PCI Express®
Card Electromechanical Specification

Revision 4.0, Version 0.70.9 Draft L

November 1527, 2018

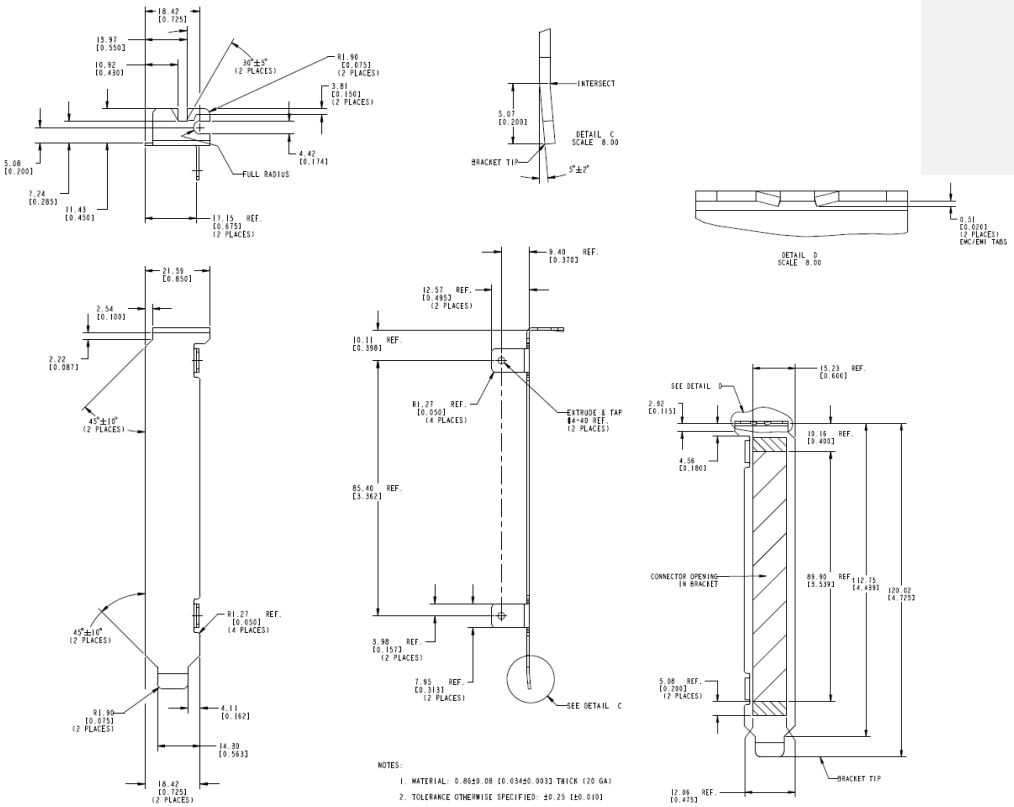
Commented [FN27]: For hockey stick to work on a x1, x4, or x8 card, the position must be the same as for a x16 card. (Figure 9-3 shows no hockey stick for x1 card, while Figure 9-4 shows hockey stick for x16 card.)

Commented [WT28]: IMPORTANT note from AMD: "This applies to more than just graphics cards (see page 100). Note: Since LP cards, can use top-side retention, they need to rely on the hockey-stick method."
They suggest removing "graphics"
